ADDENDUM NO. 1

To: All Plan Holders of Record and Interested Parties
City of Galena, Illinois
Project: East Side Utility System Improvements
IIW Project No.: 17054
Issue Date: March 12, 2020

WATER MAIN NOTES

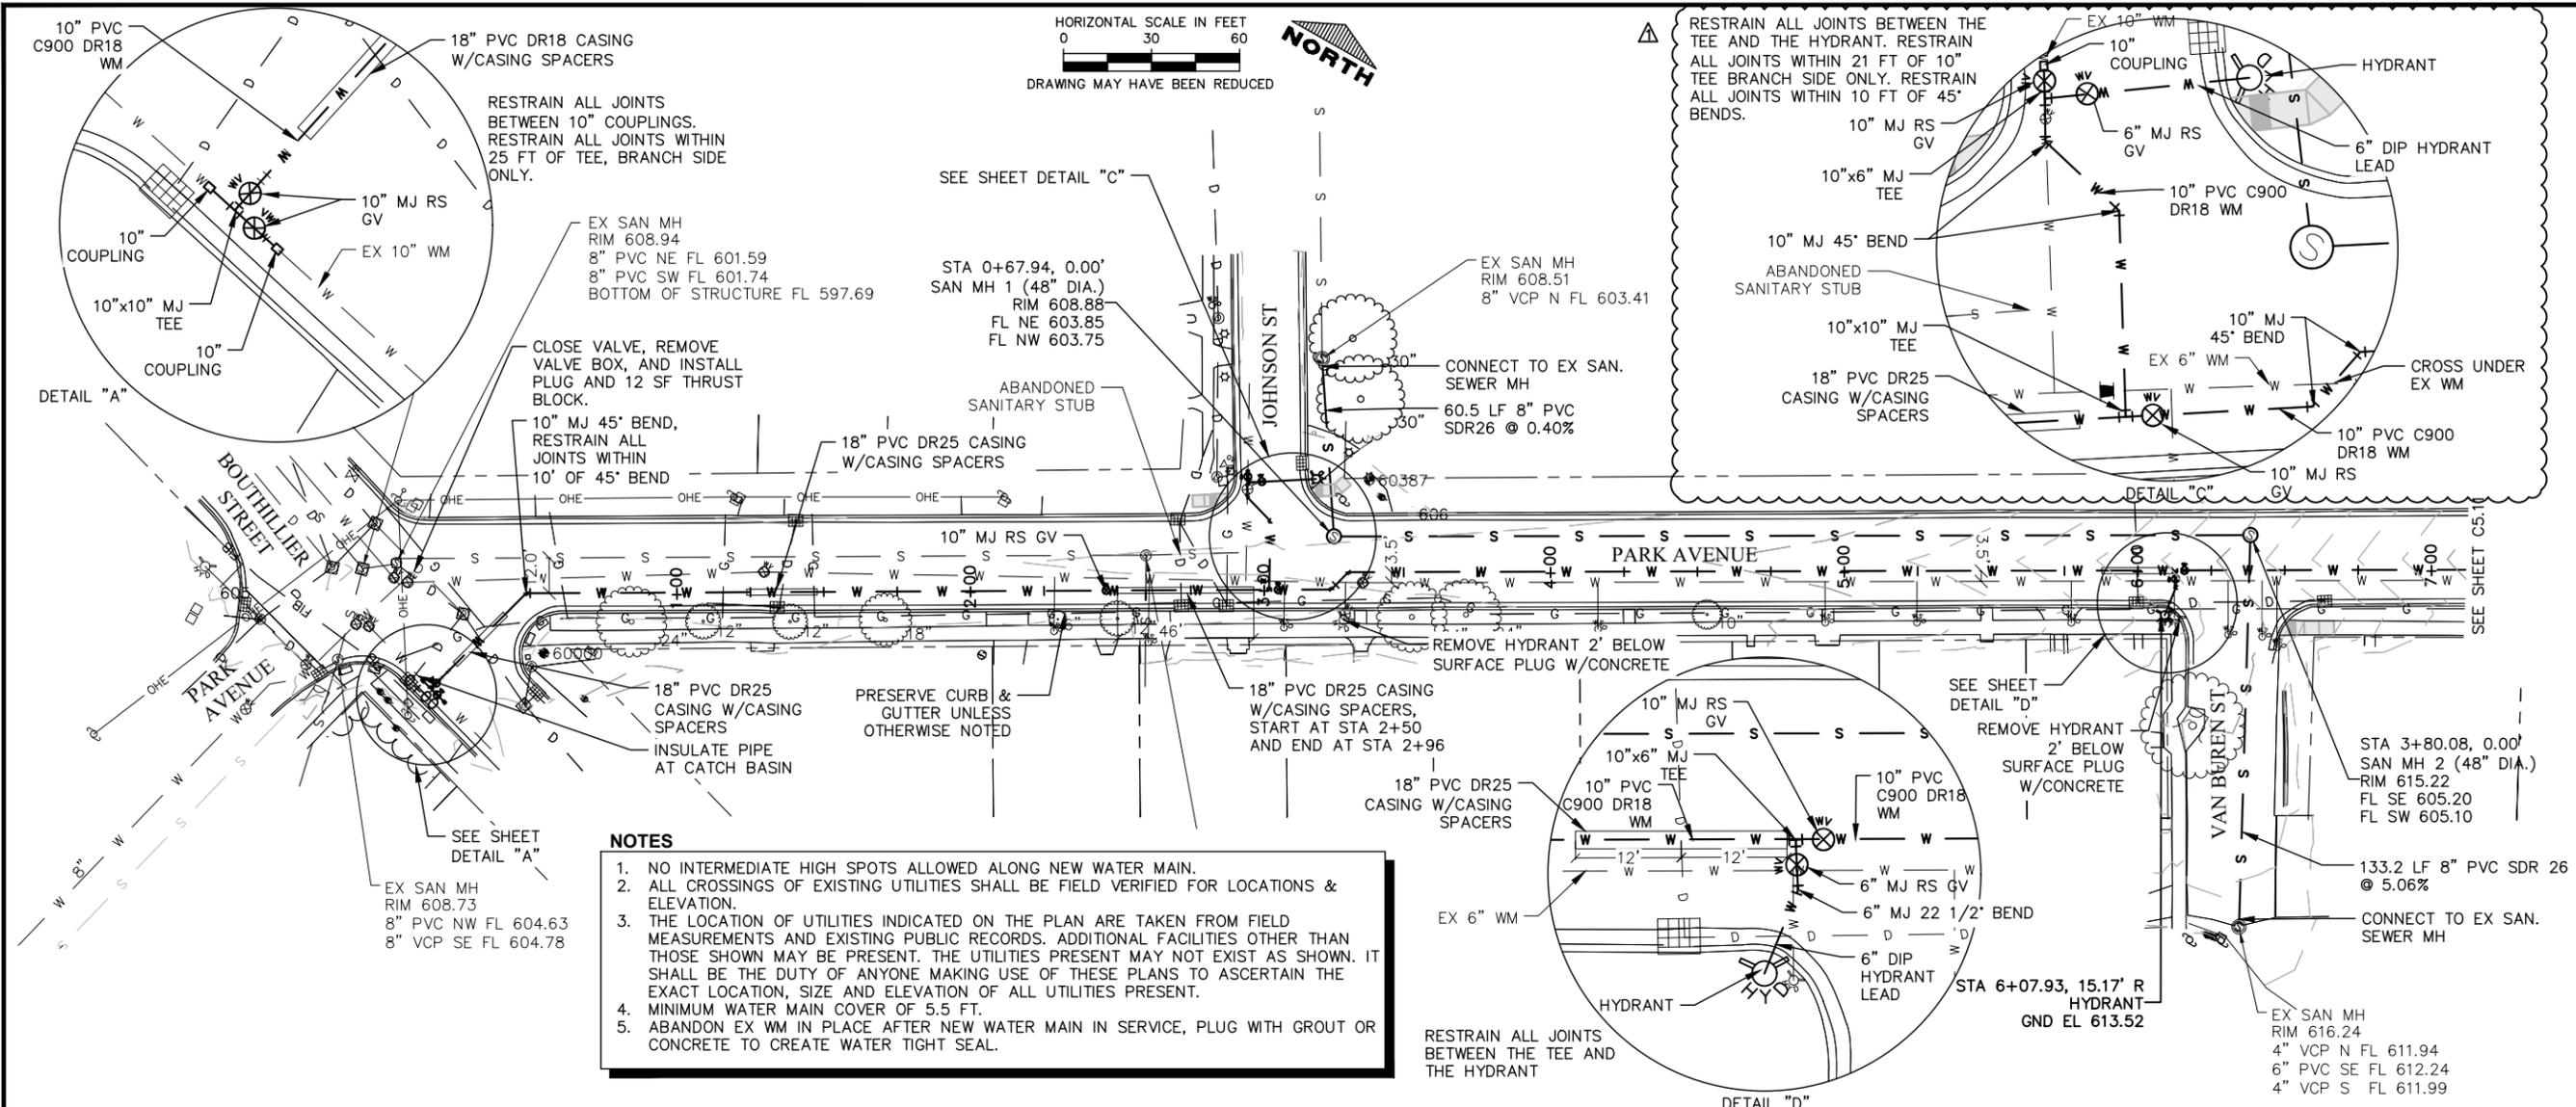
1. Sheet C5.01: Added water main notes that describe the horizontal and vertical separation between water mains and sewers.
2. Sheet C5.10: The water main alignment and vertical profile from Station 2+25 to 3+40 along Park Avenue was modified and the casing was lengthened. The water main connection at the intersection of Park Avenue and Johnson Street was also modified to meet the horizontal sewer separation requirements of the Illinois EPA.

1. HORIZONTAL SEPARATION:
 WATER MAINS SHALL BE LOCATED AT LEAST TEN (10) FEET HORIZONTALLY FROM ANY EXISTING OR PROPOSED DRAIN, STORM SEWER, SANITARY SEWER, COMBINED SEWER OR SEWER SERVICE CONNECTION. REFER TO STANDARD DRAWING NO. 18 IN THE ILLINOIS STANDARD SPECIFICATIONS FOR WATER & SEWER CONSTRUCTION IN ILLINOIS, 7TH EDITION, 2014.

2. VERTICAL SEPARATION:
 A WATER MAIN SHALL BE SEPARATED FROM A SEWER SO THAT ITS INVERT IS A MINIMUM OF EIGHTEEN (18) INCHES ABOVE THE CROWN OF THE DRAIN OR SEWER WHENEVER WATER MAINS CROSS OVER STORM SEWERS, SANITARY SEWERS OR SEWER SERVICE CONNECTIONS. THE VERTICAL SEPARATION SHALL BE MAINTAINED FOR THAT PORTION OF THE WATER MAIN LOCATED WITHIN TEN (10) FEET HORIZONTALLY OF ANY SEWER OR DRAIN CROSSED. A LENGTH OF WATER MAIN PIPE SHALL BE CENTERED OVER THE SEWER TO BE CROSSED WITH JOINTS EQUIDISTANT FROM THE SEWER OR DRAIN.

**WATER MAIN & SANITARY SEWER
PLAN & PROFILE**
CITY OF GALENA
EAST SIDE UTILITY
SYSTEM IMPROVEMENTS

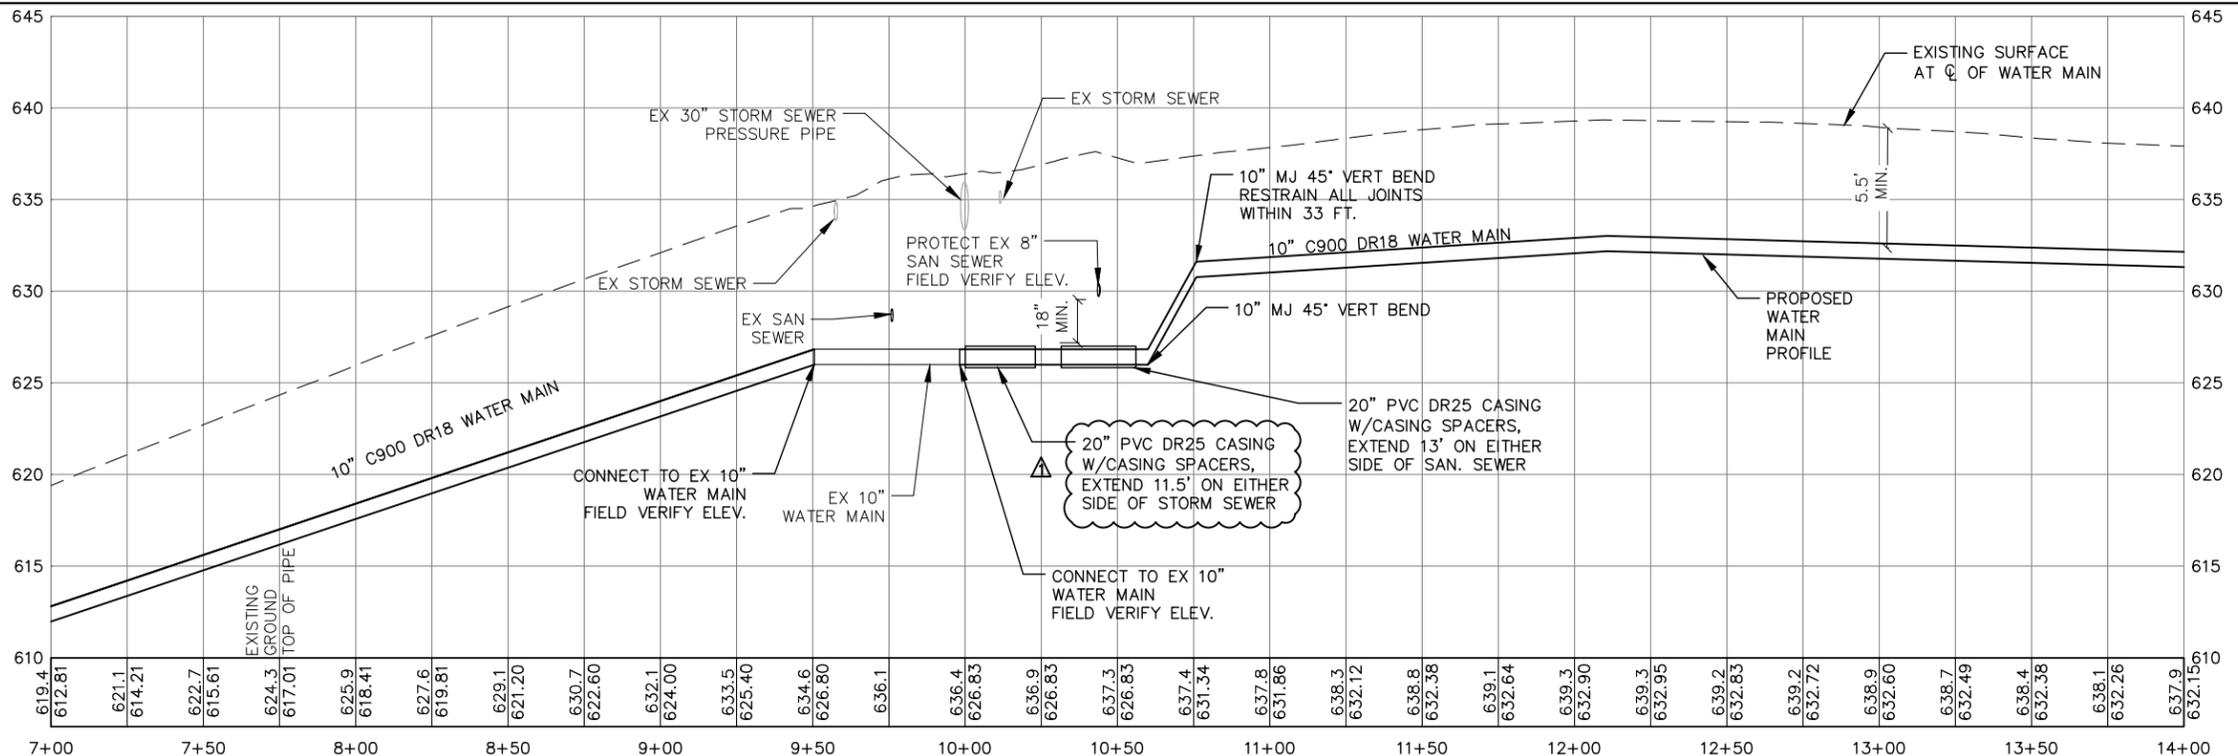
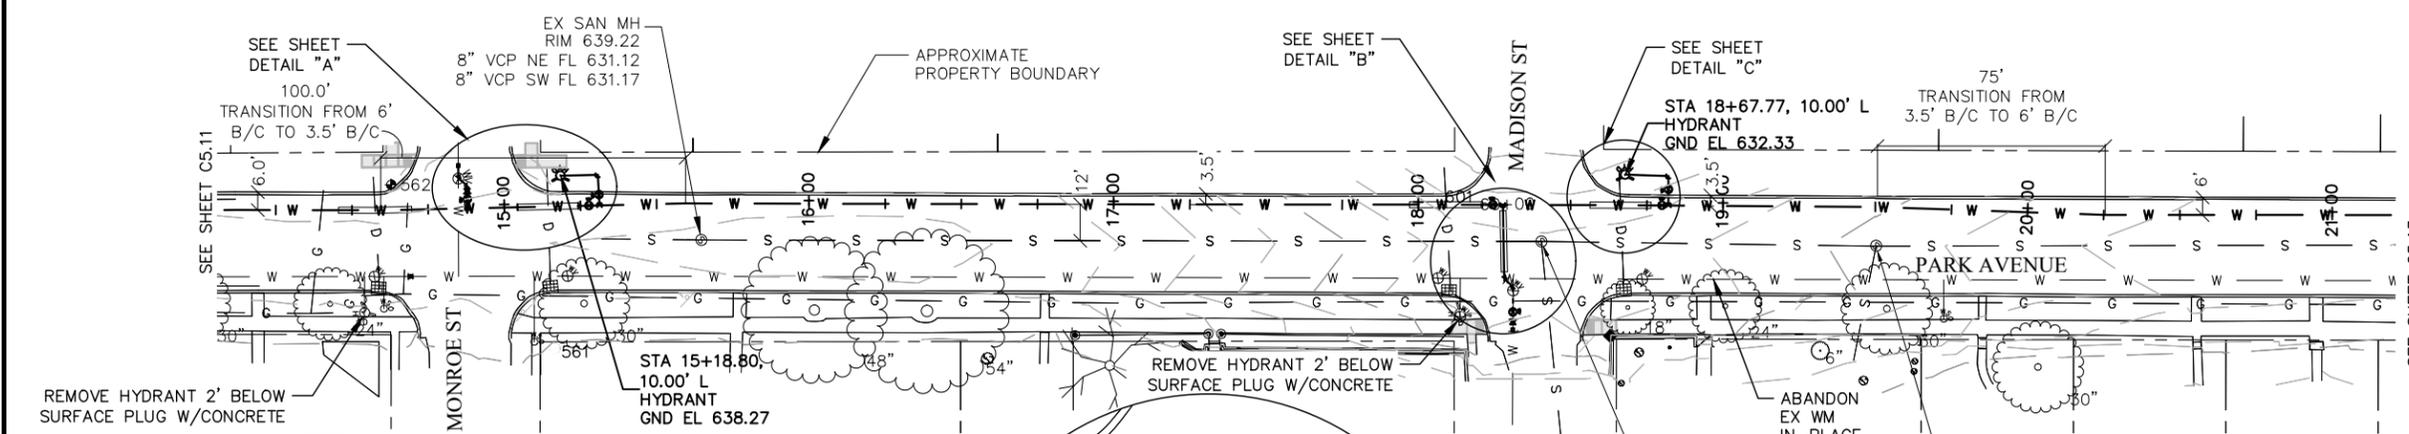
3. Sheet C5.11: Twenty-three (23) feet of 20-in. PVC DR 25 casing was added to the project to comply with the Illinois EPA vertical separation requirements when the water main crosses beneath a sewer.

C5.12
Project No: 17054

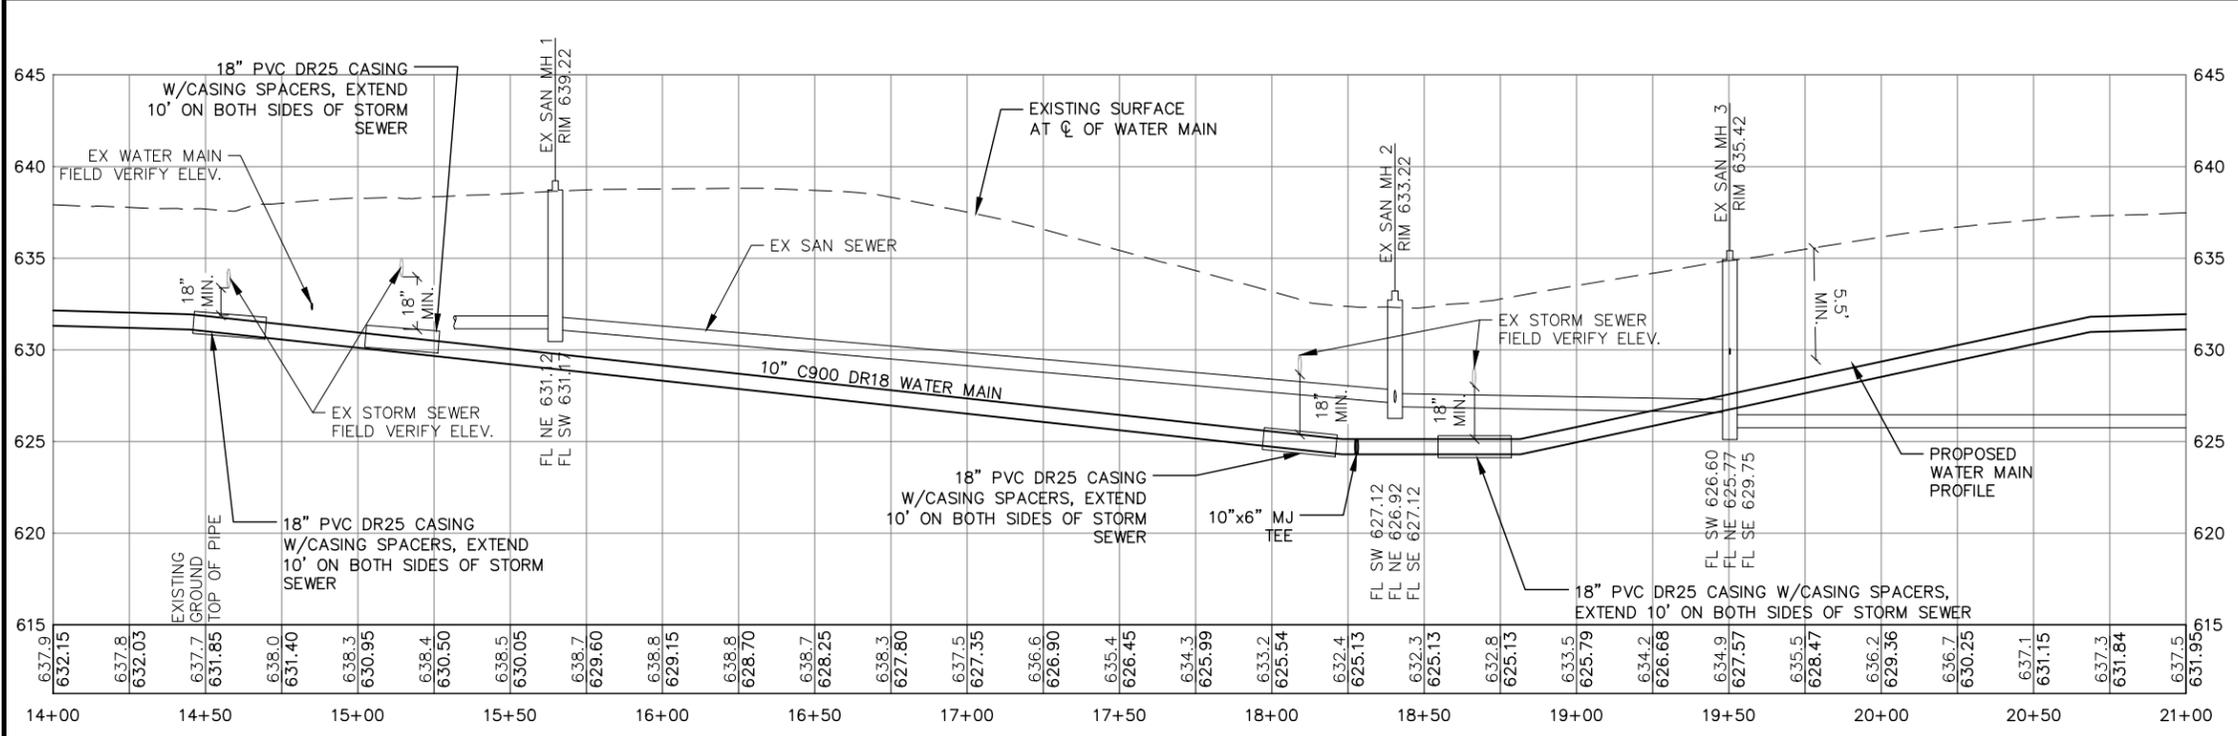
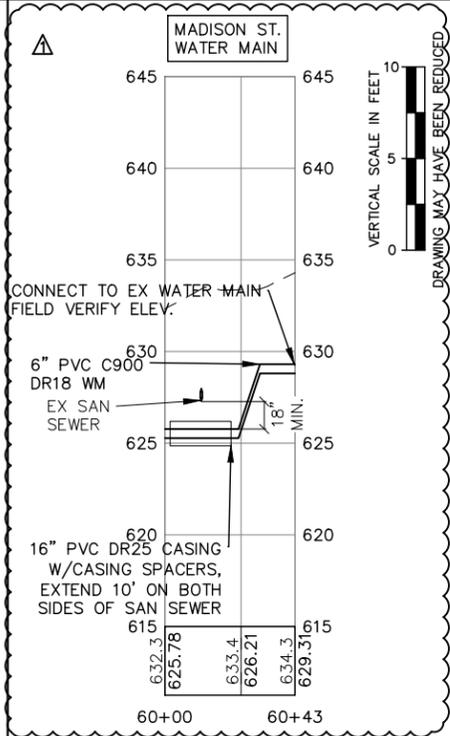
4. Sheet C5.12: A profile of the 6-in. water main on Madison Street was added to the plan sheet to indicate the vertical separation requirements when the water main crosses beneath the existing sewer.

**WATER MAIN & SANITARY SEWER
PLAN & PROFILE
CITY OF GALENA
EAST SIDE UTILITY
SYSTEM IMPROVEMENTS**

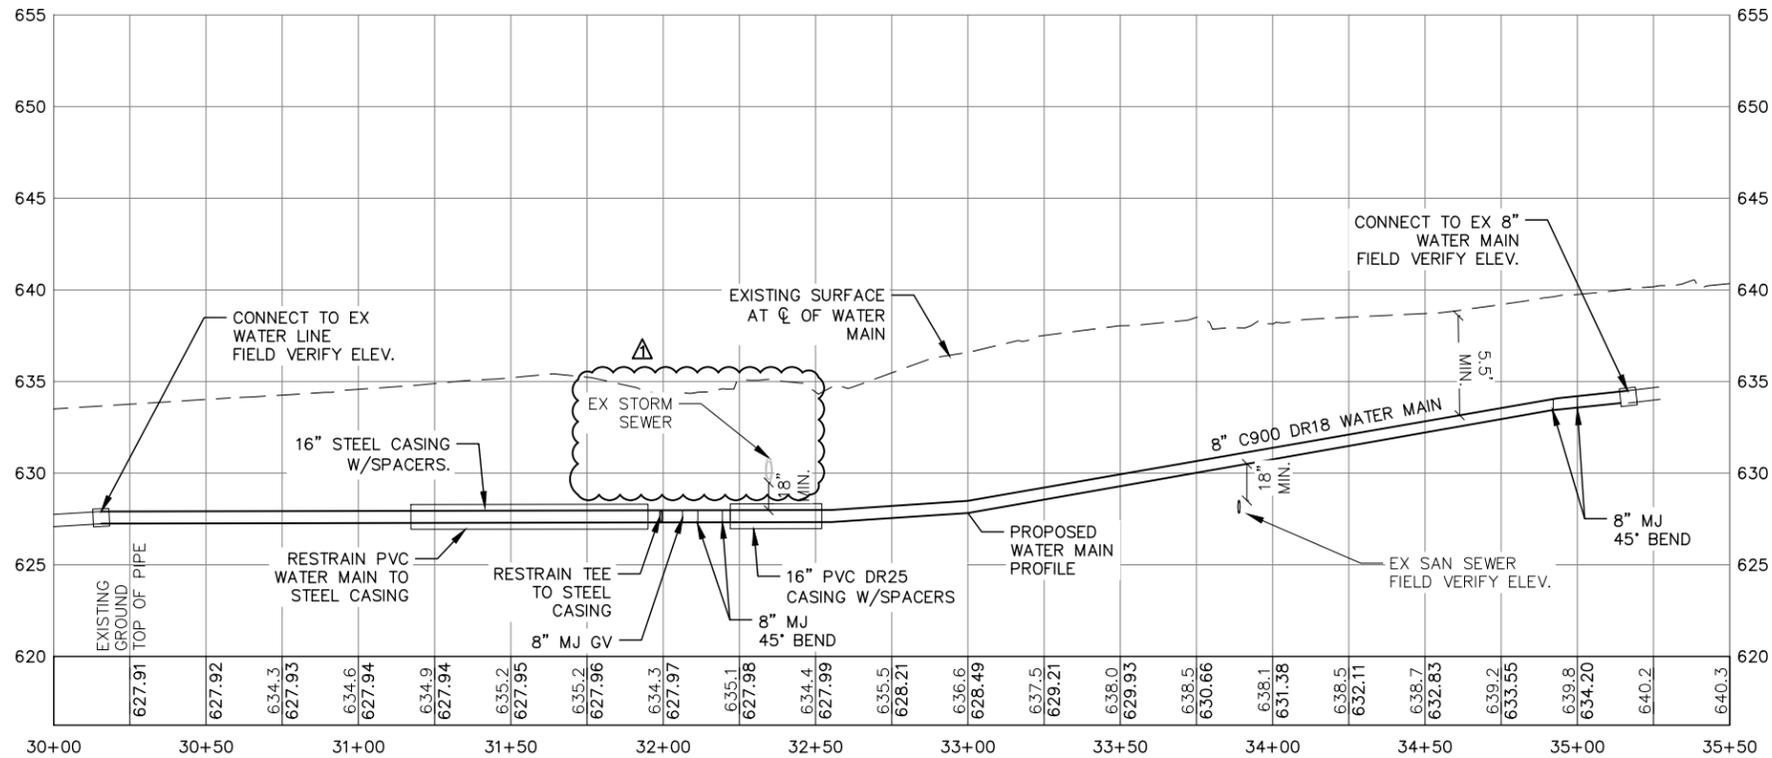
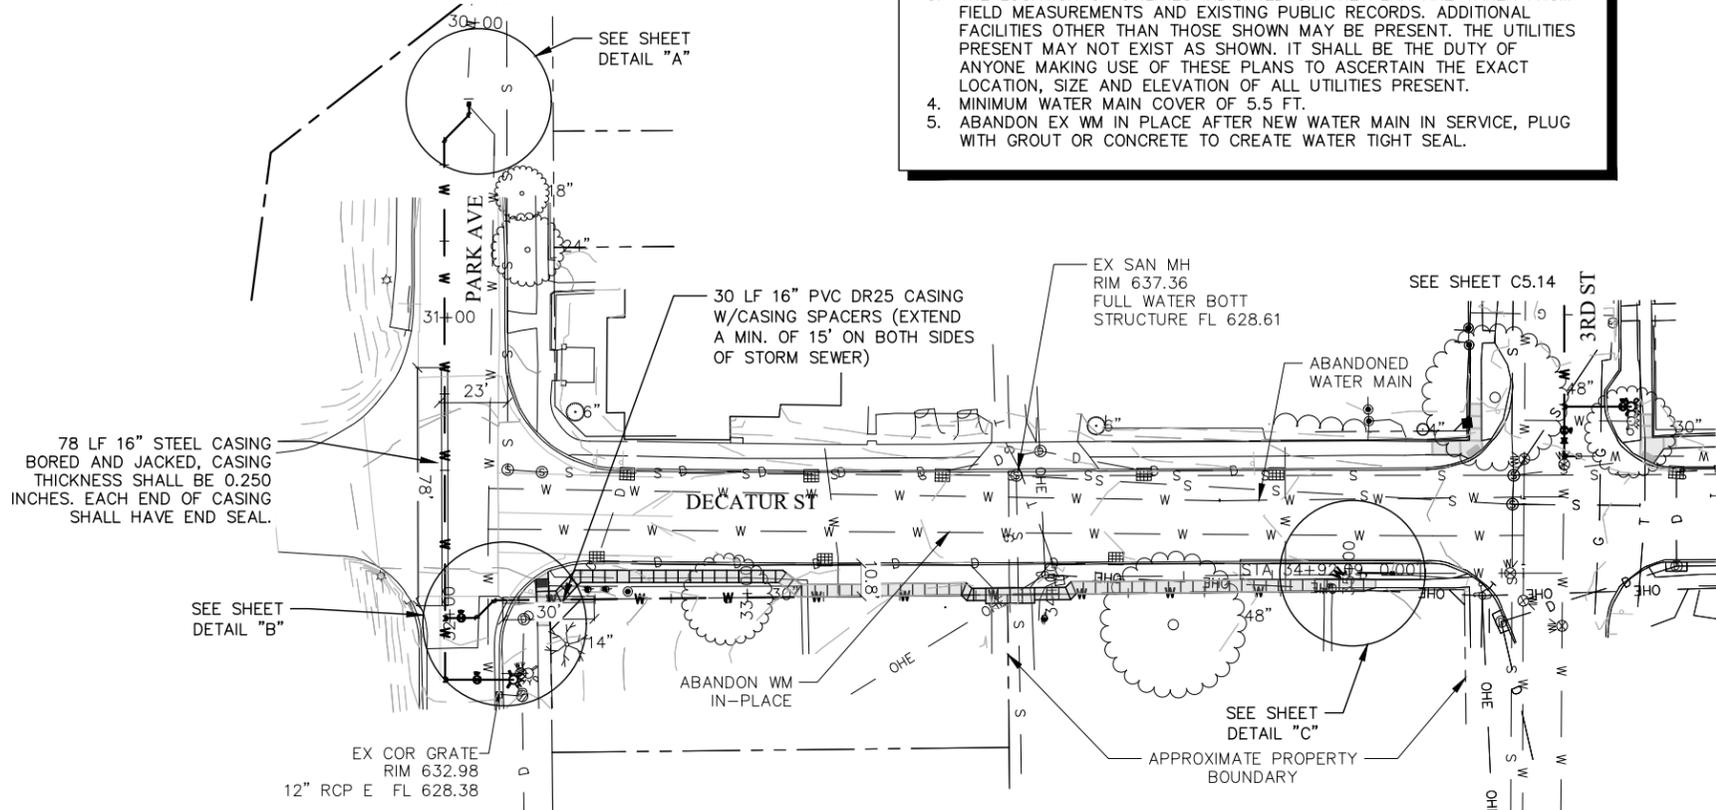
5. Sheet C5.15: The location of existing storm sewer at Station 32+35 shown in the profile was moved to depict the correct location of the storm sewer crossing.

9 TYPICAL SIDEWALK
C6.01 NOT TO SCALE

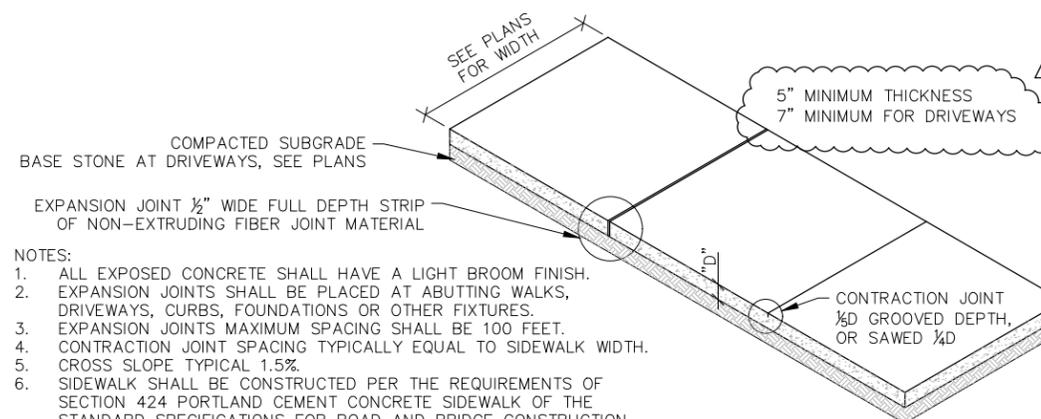
6. Sheet C6.01: The typical sidewalk detail was updated. The PCC sidewalk thickness changed from 4" to 5". The PCC driveway thickness changed from 6" to 7".
